The Department offers the following additional comments specific to Items 1-4 in ZPMC's letter:

Figure 1: Typical Fabricated Bottom Plate without Stiffeners

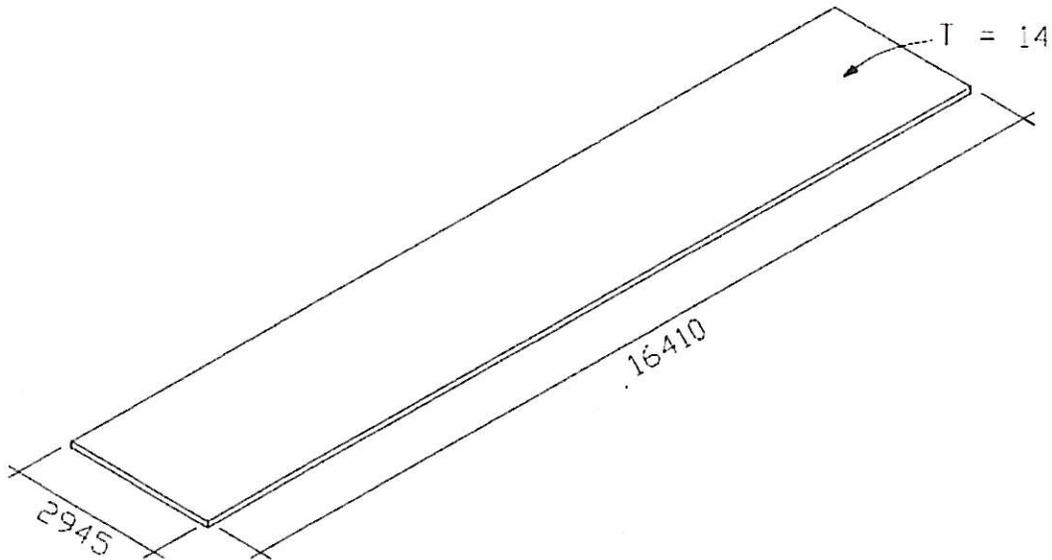
For example, if a 2.945m x 16.41m typical bottom plate without stiffeners is fabricated by butt-welding 14mm thick plates together as shown in Figure 1, then the least dimension along the boundary of panel would be 2.945 m or 115.90 inches between the plate edges. Since T is defined as, "*the minimum thickness in inches of the plate comprising the panel,*" and the thickness is equal to 14mm or 0.55 inches, the maximum deviation from detailed flatness would not exceed the greater of:

$$5 \text{ mm or } \frac{115.9}{144 \sqrt{0.55}} = 1.08 \text{ " or } 28 \text{ mm}$$

Since 28mm > 5mm, 28mm would govern in this case for the unstiffened plate. However, once stiffeners are welded onto the plate, the least dimension along the boundary panel becomes the least dimension between the stiffeners, which is 420mm or 16.54 inches (see Figure 2). The maximum deviation from detailed flatness for the stiffened plate would not exceed the greater of the following:

Figure 2: Typical Fabricated Panel with Closed U-Ribs and WT Ribs

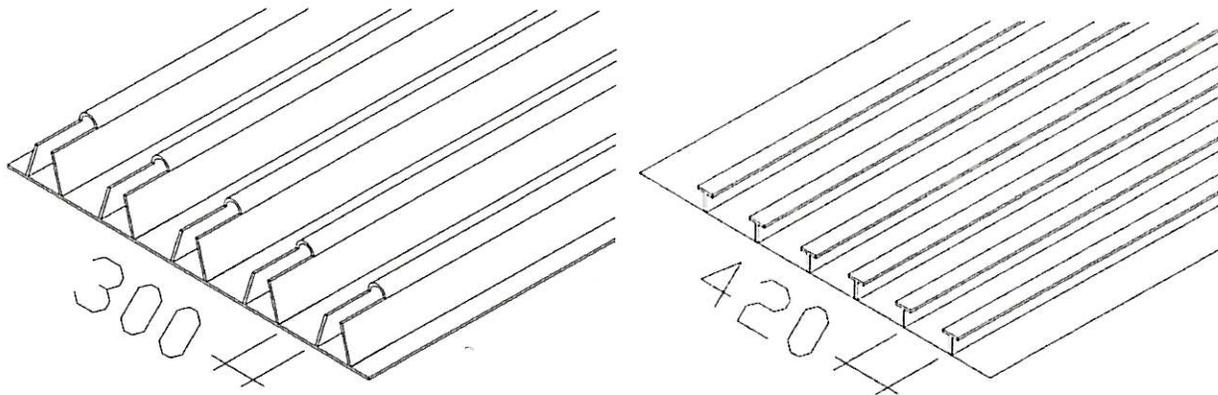
$$5 \text{ mm} \text{ or } \frac{16.54}{144 \sqrt{0.55}} = 0.15 \text{ " or } 4.0 \text{ mm}$$

Since 5mm > 4mm, 5mm would be the governing panel flatness for the stiffened panel.

For the WT stiffened panel shown in Figure 2, the local flatness requirements would be checked with a straightedge not exceeding  $1.5 \times 420\text{mm} = 630\text{mm}$ . The section also states that the deviations “*shall be measured between adjacent points of contact of the template edge with the element.*” The 630mm long template (straightedge) could be used to check both transversely between stiffeners, and along the length of the stiffeners to determine local deviations as shown in Figure 3.

Figure 4: Typical Floor Beam Spacing of 5m

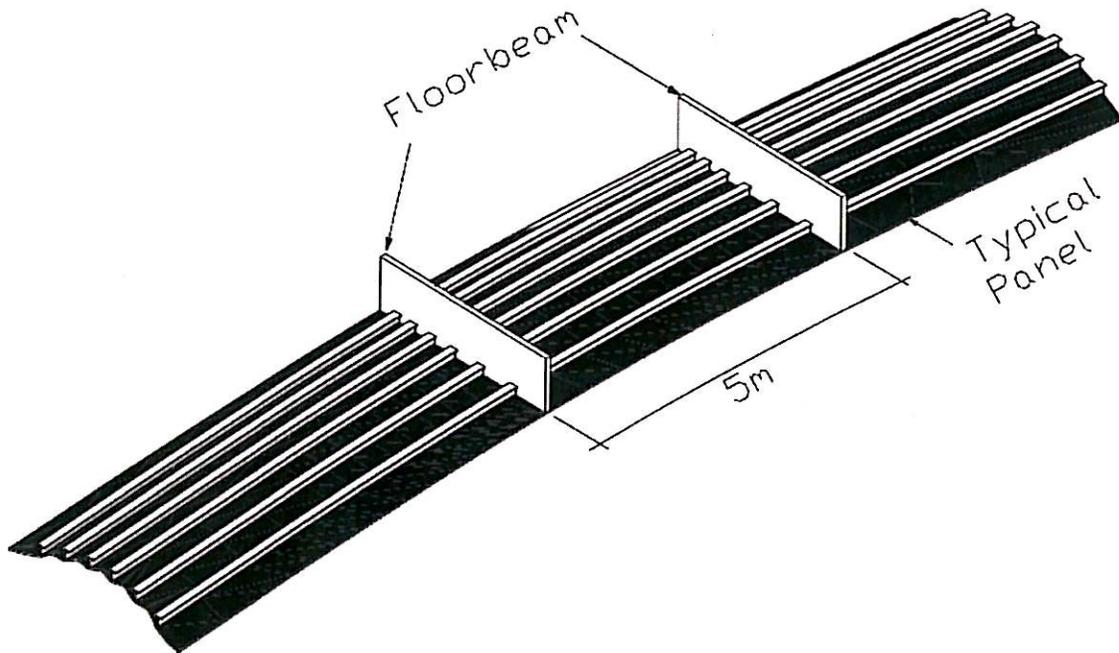
Once floor beams are placed on the panel, typically at 5m intervals as shown in Figure 4, an “element,” defined by the steel area bounded by the panel stiffeners, is equal to 420mm x 5m.

Figure 5: Five-Meter Straightedge Measurements Transversely and Along the Length of the OBG

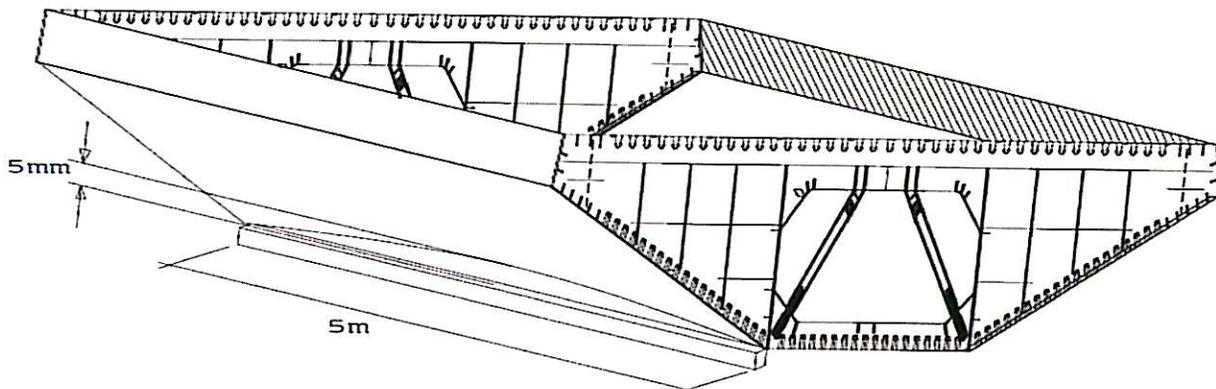
To determine global flatness deviations of this element, a straightedge "not exceeding the greatest dimension of the element being examined..." of 5m in length could be used as shown in Figure 5. As specified above, the maximum deviation measured shall not exceed the greater of either:

When a panel is bound by stiffeners 420mm x 5m long, D is then equal to 420mm. With T=14mm, the maximum flatness deviation of the element measured between the 5m floor beams is governed by a panel flatness of 5mm.
